## VP01 Point Arkwright

**Table 4: Assessment Summary for VP01**

**Figure 24: Photo From Near Vantage Point Showing Cranes**

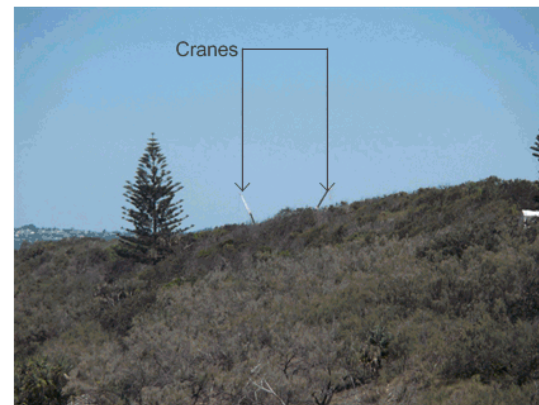
1. This vantage point is highly sensitive - it is a well visited lookout where the view is dominated by an attractive, natural landscape.
2. The proposed hotel (at 10 storeys) will be clearly visible and will have a significant impact on the view, it will be a visible intrusion of built form in an almost wholly natural landscape - the outcome would be unacceptable without substantial changes.

3. For Option 1, it appears that the proposal would not be visible above the dune vegetation. As such, the impacts would be negligible.
4. For Option 2, a very small part of the hotel (at 8 storeys) would be visible, but may not be particularly noticeable, depending on the architectural treatments and colours employed. As such, the impacts would be low.

5. In all instances, the dune topography and vegetation plays an important role in obscuring proposed built form. Conditions requiring protection of dune vegetation are likely to be required. Controls on lighting for upper parts of any development above 6 storeys likely to be required.
